PERFORMANCE SPECIFICATION SHEET

SWITCHES, SENSITIVE, MOMENTARY, 4 CIRCUIT
OR DPDT (10 AMPERES), UNSEALED

This amendment forms a part of MIL-PRF-8805/77H, dated 19 September 2000, and is approved for use by all Departments and Agencies of the Department of Defense.

MIL-PRF-8805/77H
AMENDMENT 1

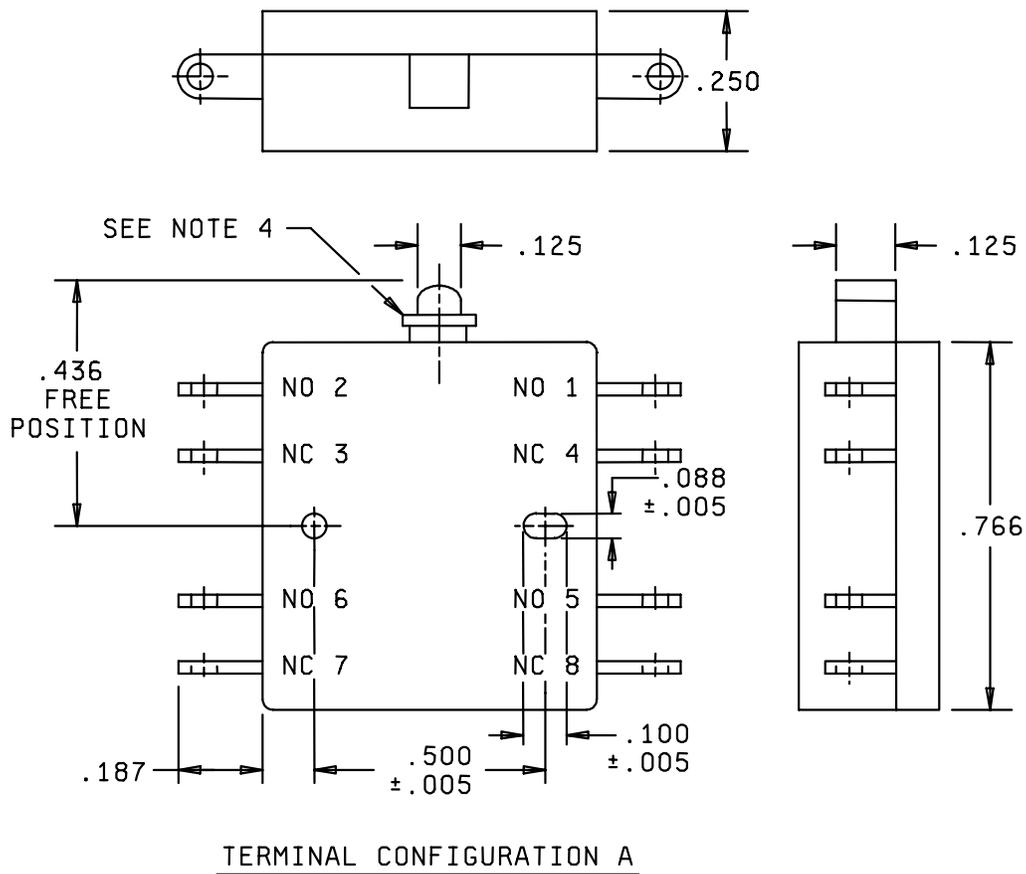
Figure 1, Delete Terminal Configuration A and replace with the following:
